Re: Addendum #1
Town of Ridgeland
Effluent Filter and Pump Hoists Project

EFFLUENT FILTER AND PUMP HOISTS

JIMMY MIXSON WATER RECLAMATION FACILITY

RELEASE	DATE	SHEETS INCLUDED	SHEETS REVISED	DESCRIPTION
A	2/12/26	Sheets 1-8	Sheets 1-8	Issued for Bidding
B	4/6/26	Sheets 1-8	Sheets 1, 3	Addendum #1

SHEET TITLE
Effluent Filters Plan

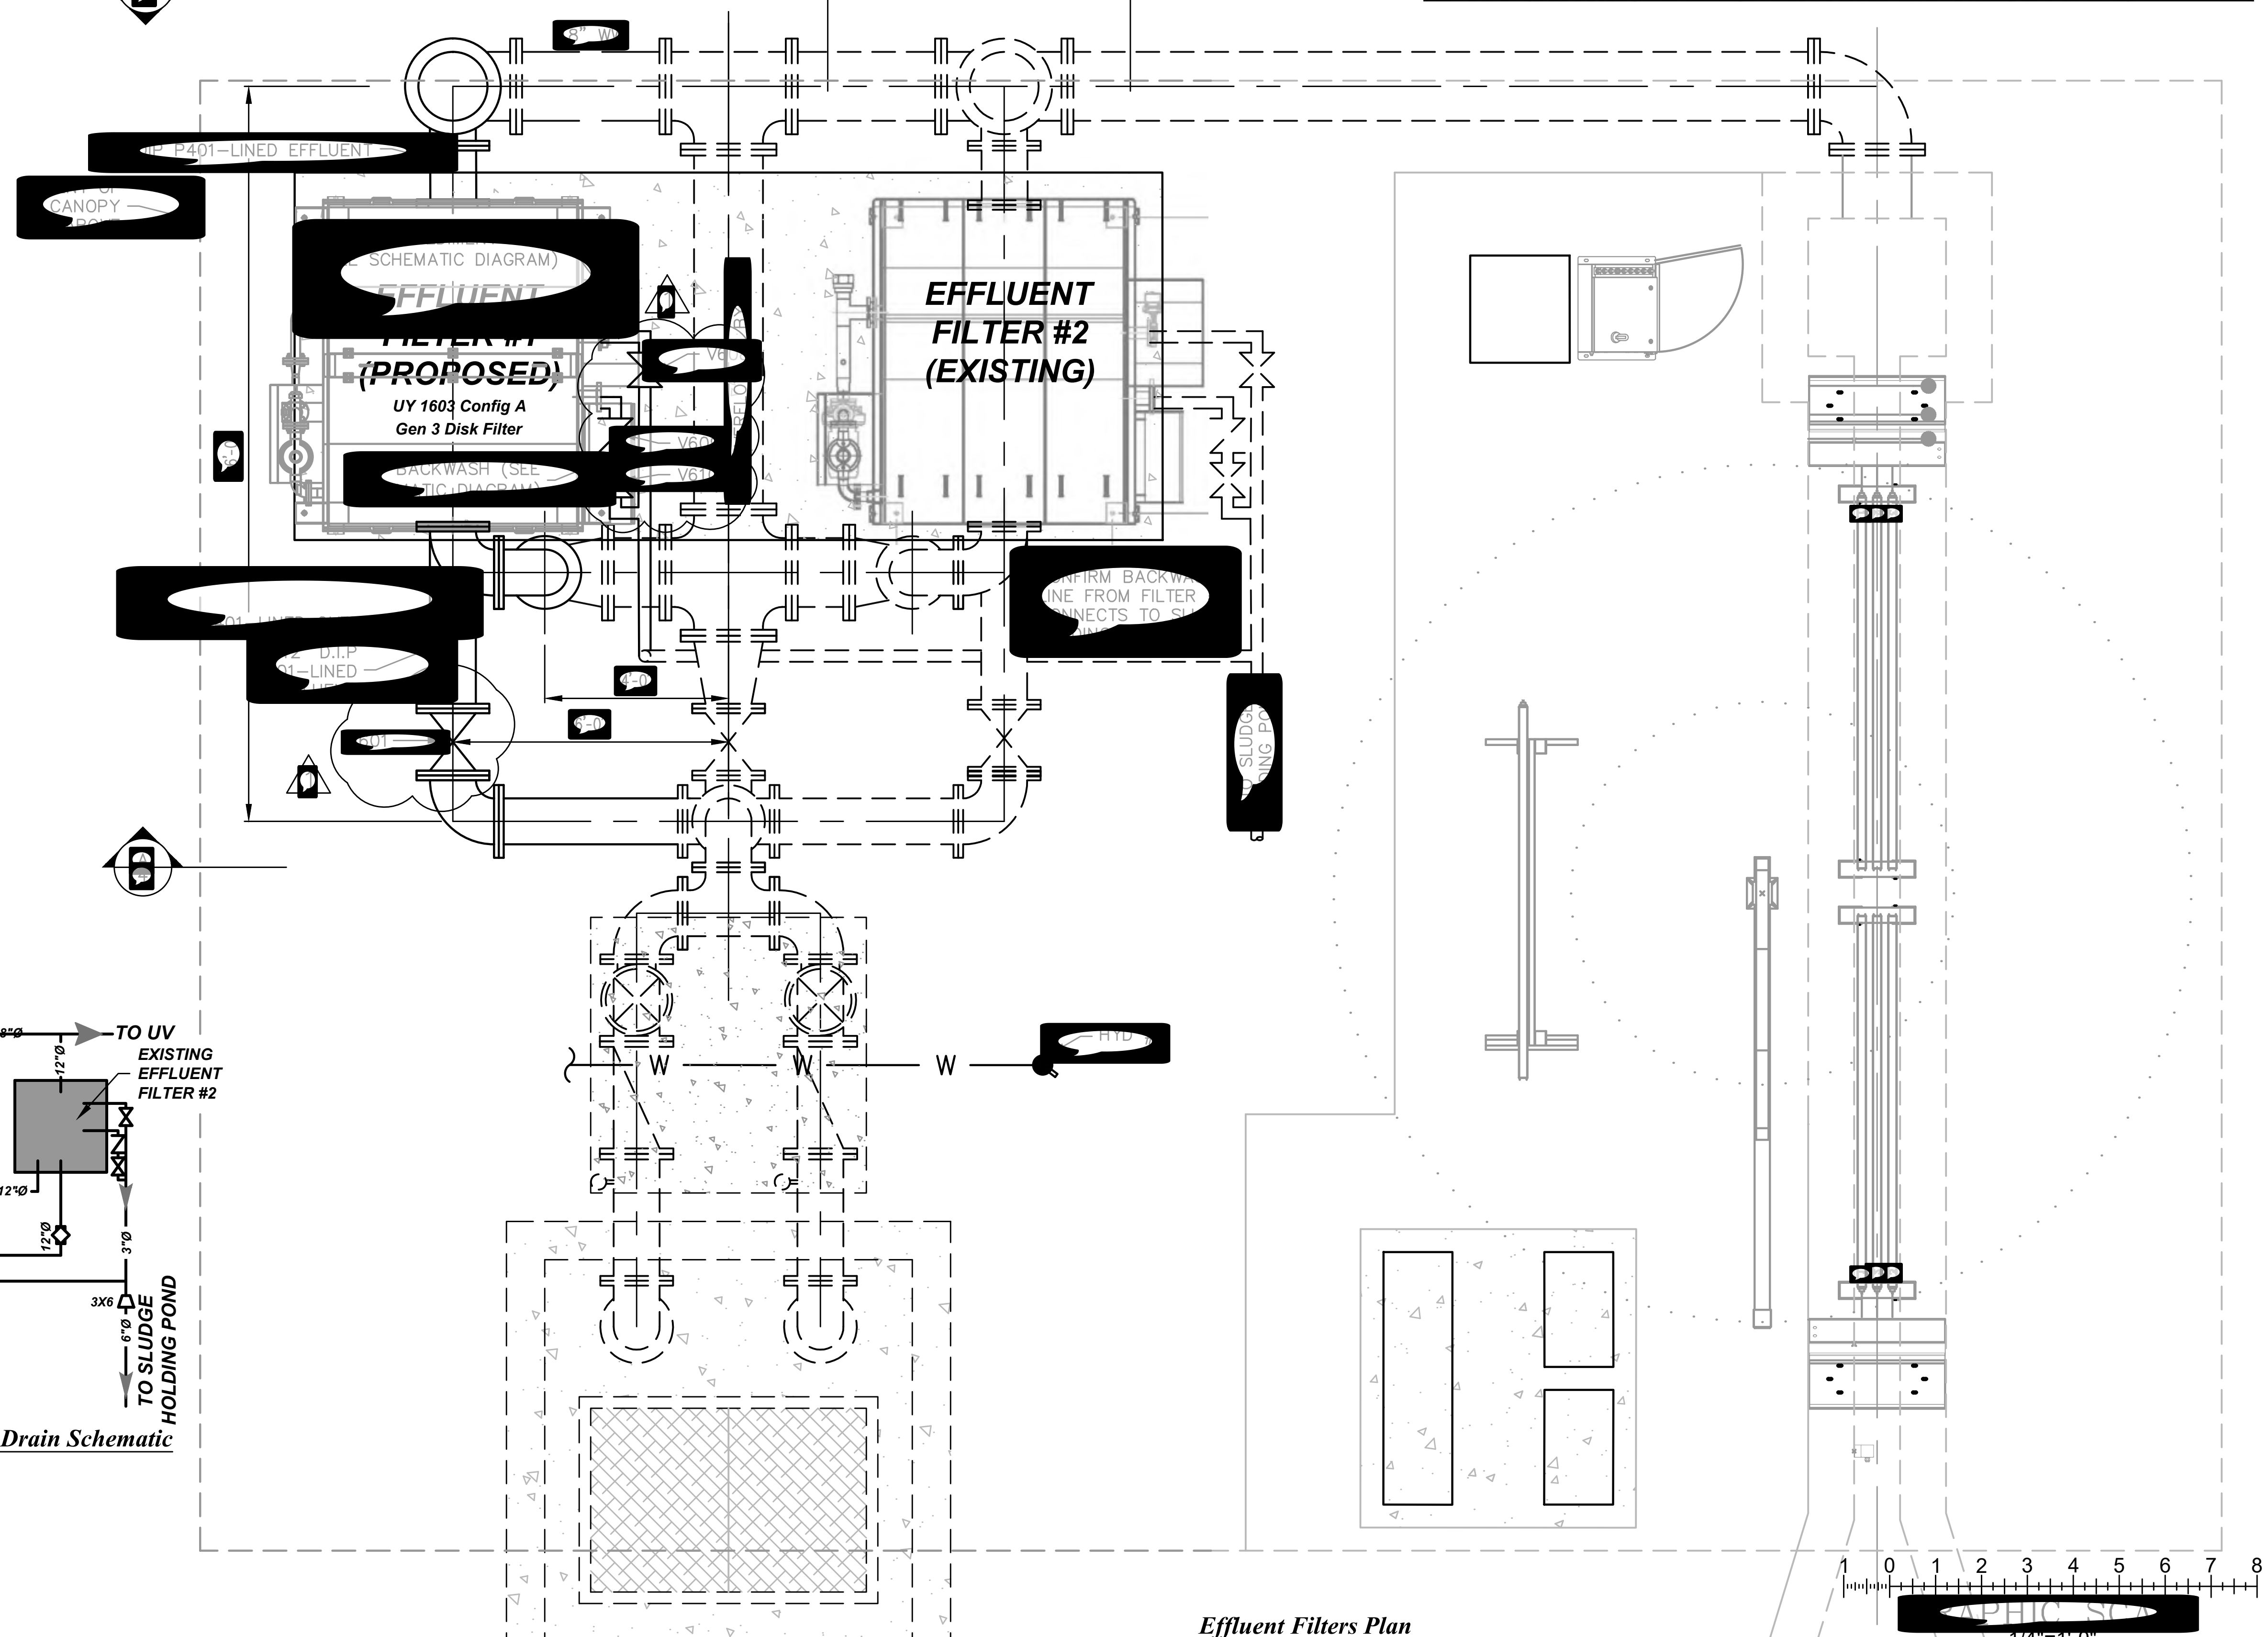
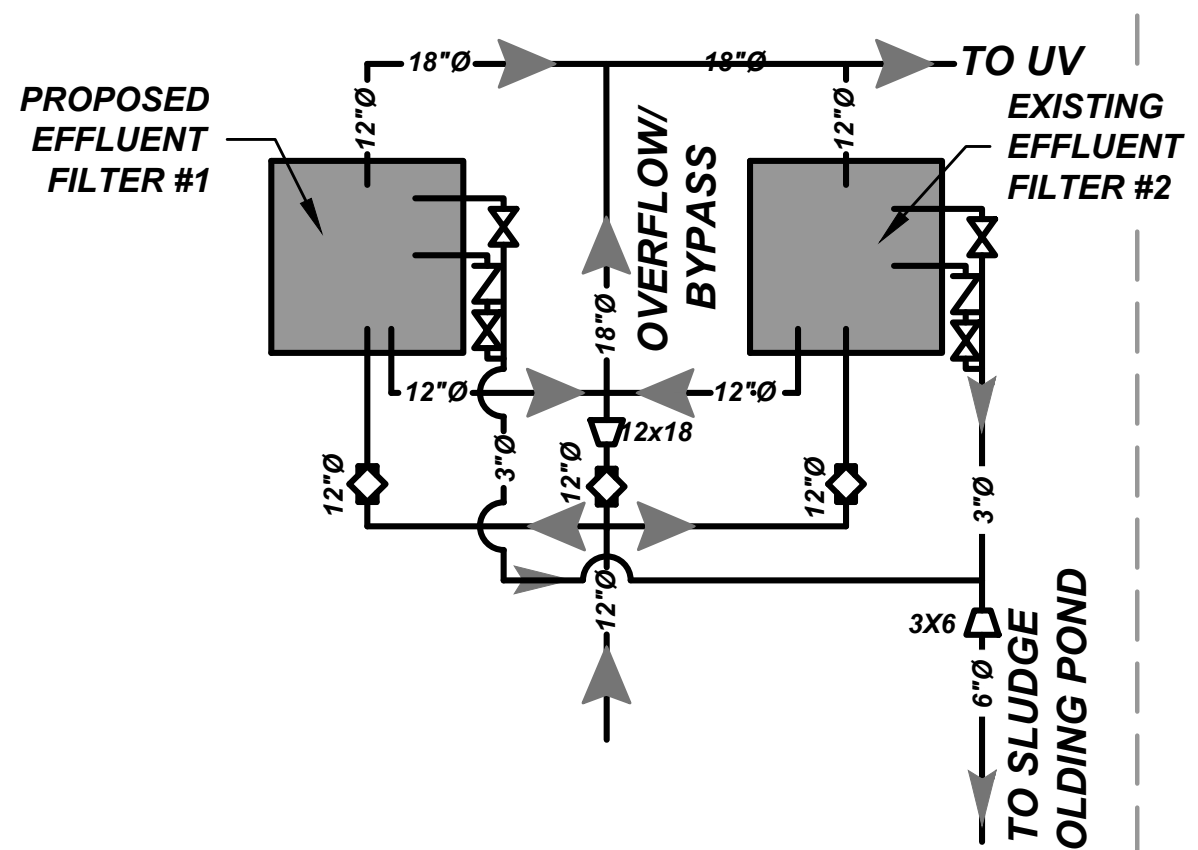
1.11	Section 41 22 13.19	Q: Please provide a specification for the jib cranes. A: See attached specification Section 41 22 13.19 – Jib Crane.
1.12	Plan Sheets 3 and 7	Q: Is it the intention to depict all existing piping with dashed lines and new piping with solid lines? If so, please clarify if the piping exiting the effluent pump station is existing as shown in page 3. Or new as shown in page 7. A: The intention is to depict all existing piping with dashed lines and proposed piping with solid lines. All effluent filter underground piping exists. See Effluent Filter existing conditions photo log.

1.13		Q: If the piping exiting the effluent pump station is new, please clarify whether it is to be configured as shown on page 3 by splitting off with a tee, or as shown on page 7, splitting off with a cross and additional valve. A: See Addundum item 1.12.

1.14	Plan Sheet 3 Section 40 23 00	Q: Please provide a valve schedule as there is no indication of valve type for proposed valves in the drawings. A: See revised Plan Sheet 3 for valve schedule included in Plan Set Release B.

Valve Schedule					
Mark	Spec	Size	Service	Type	Actuator
V601	40 23 00	12"	Effluent Filter #1 Inlet	Butterfly	Handwheel
V608	40 23 00	3"	Filter #1 Sediment Drain	PVC Ball	
V609	40 23 00	3"	Filter #1 Backwash Reject	PVC Check	
V610	40 23 00	3"	Filter #1 Backwash Reject	PVC Ball

NO	DATE	DESCRIPTION	BY
1	4/6/26	LABEL VALVES AND ADD SCHEDULE	BAR
0	2/12/26	INITIAL	BAR

SHEET TITLE *Electrical Layout Plan and 1-Line Diagram*

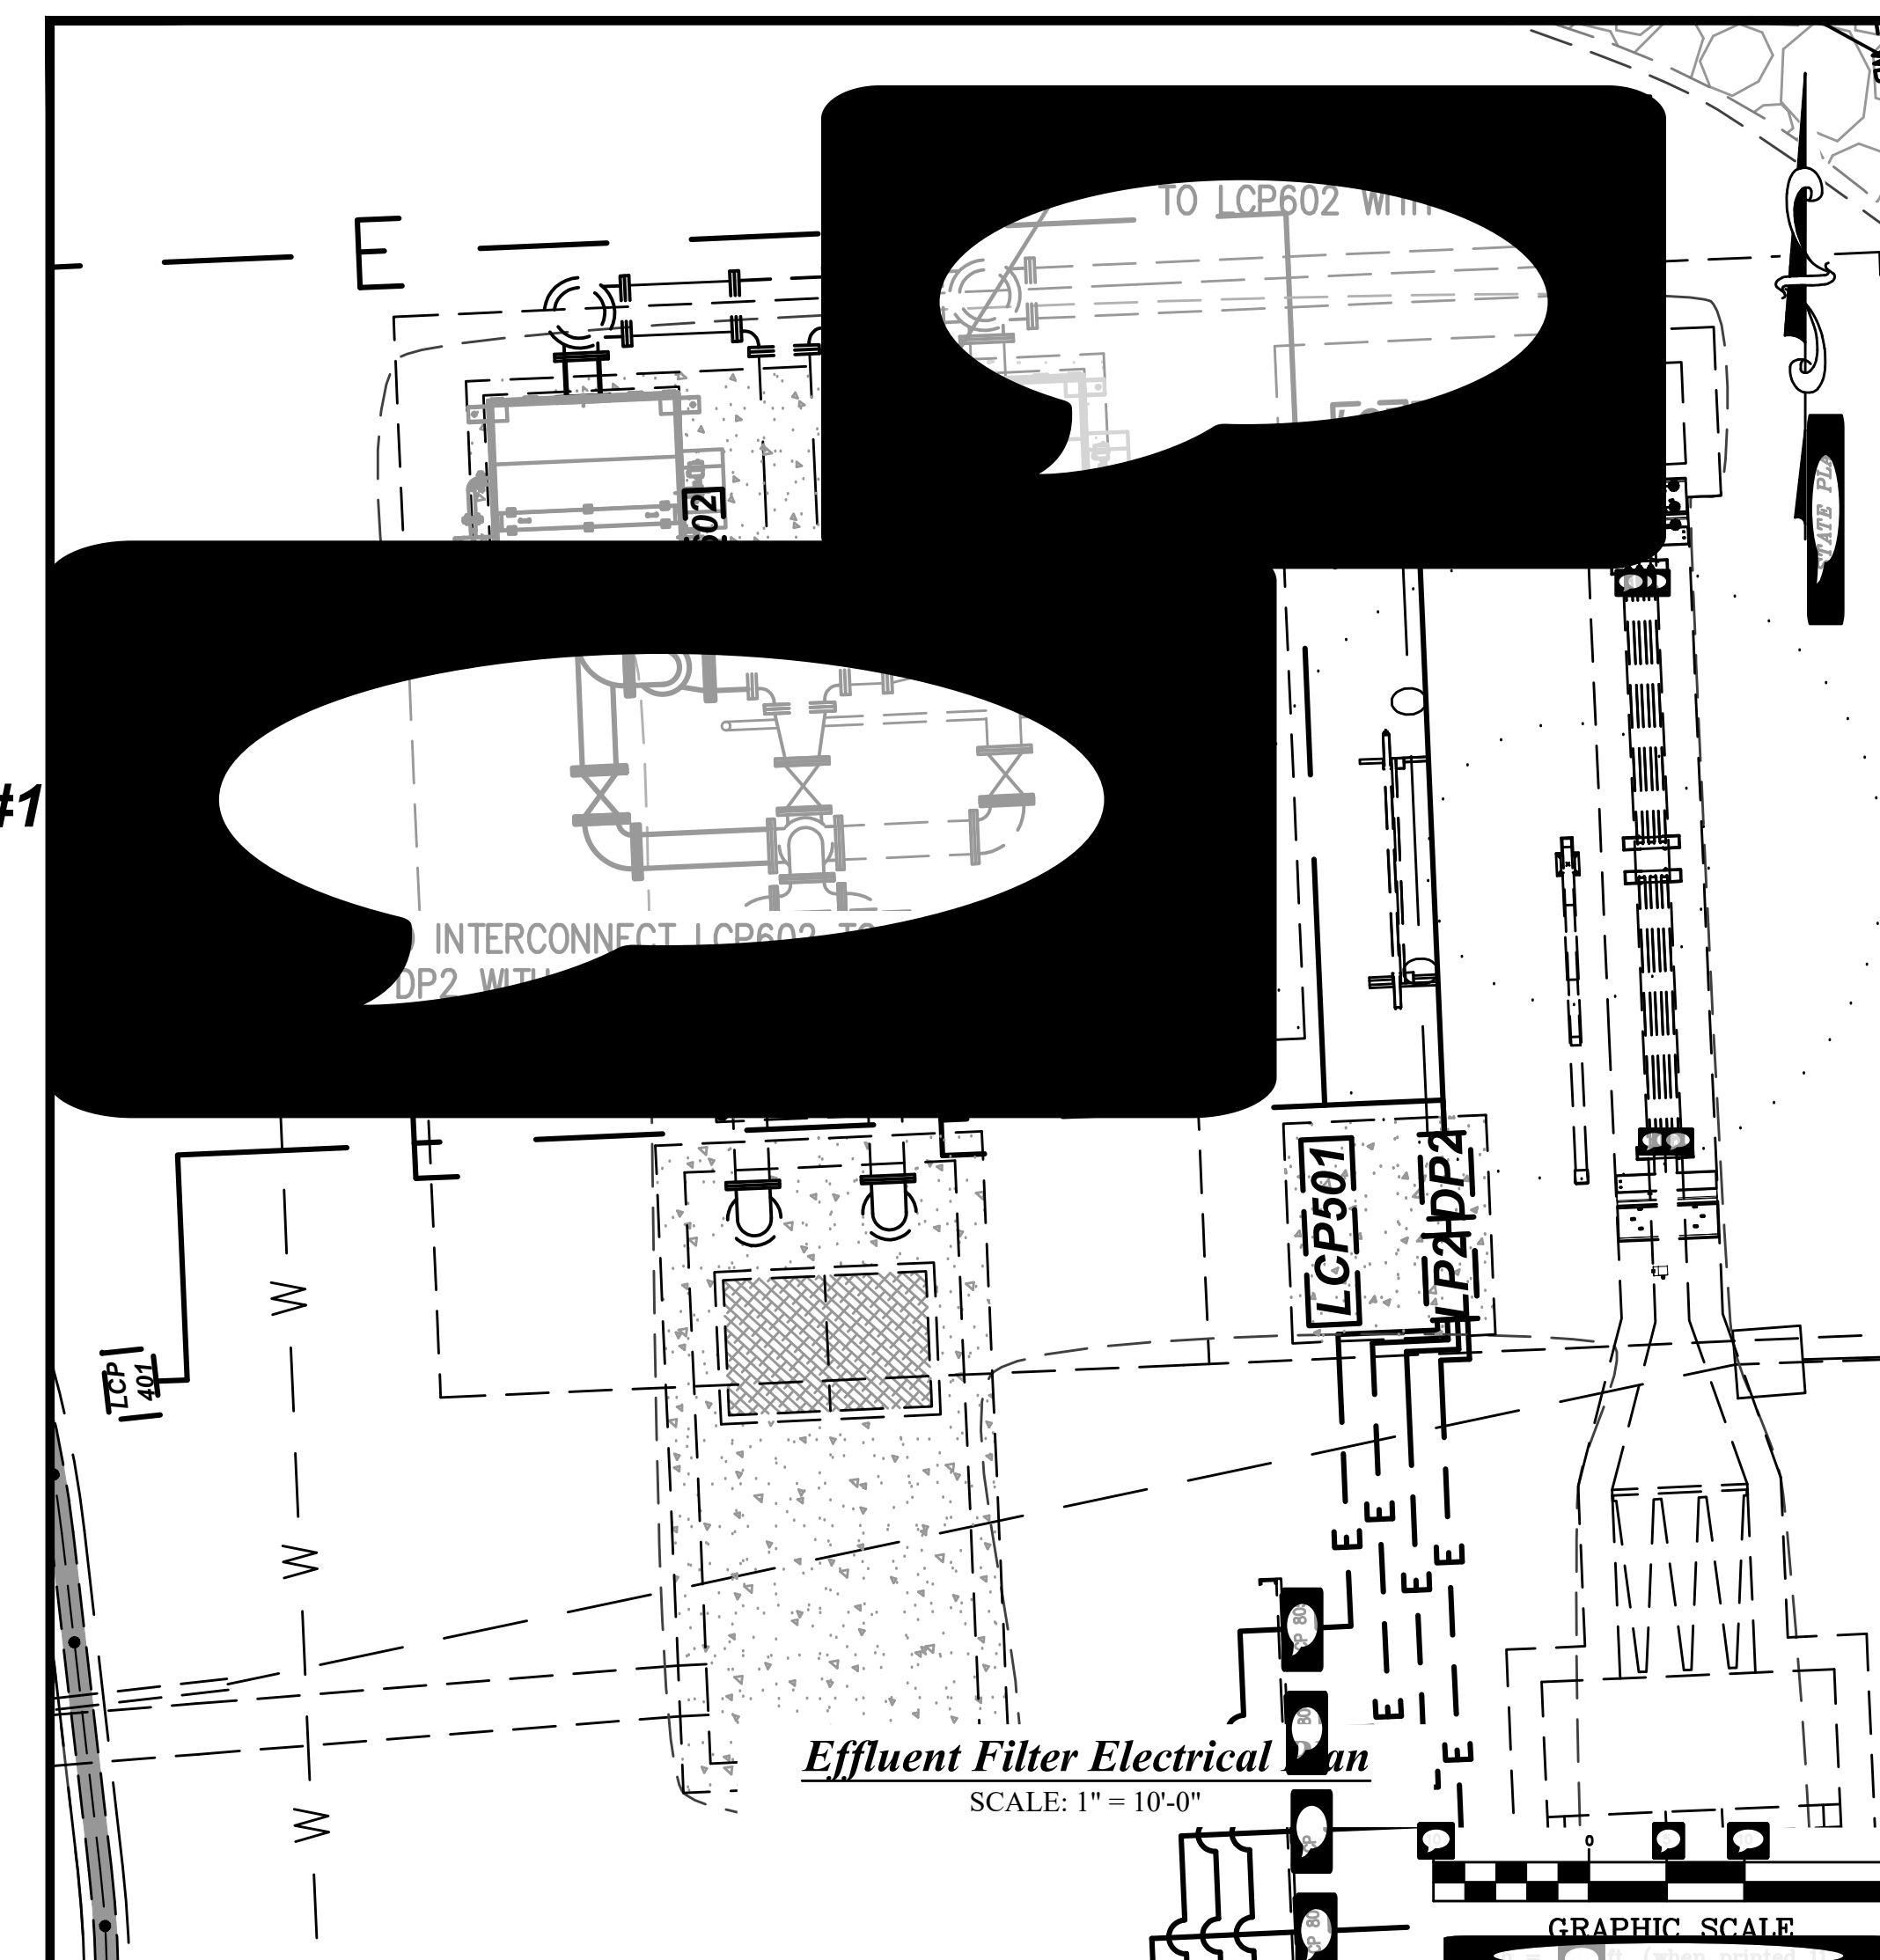
1.2	Plan Sheet 5	Q: Can you confirm that SCADA is not being paid by the contractor? A: The contractor's scope of work is to land CAT6 connections from the proposed effluent filter to the existing Effluent RTU, approximately 30 feet from the proposed effluent filter. The Owner's SCADA integrator will provide programming and software additions to the existing SCADA.

1.22	Section 26 05 00	Q: Is there any OCAL required for our scope of work? A: OCAL, PVC coated rigid steel conduit, is not required.
1.23	Plan Sheet 5	Q: Are contractors required to provide breakers for disk filters? A: Contractors are to provide all necessary electrical equipment so that the Project Work is complete and functional.
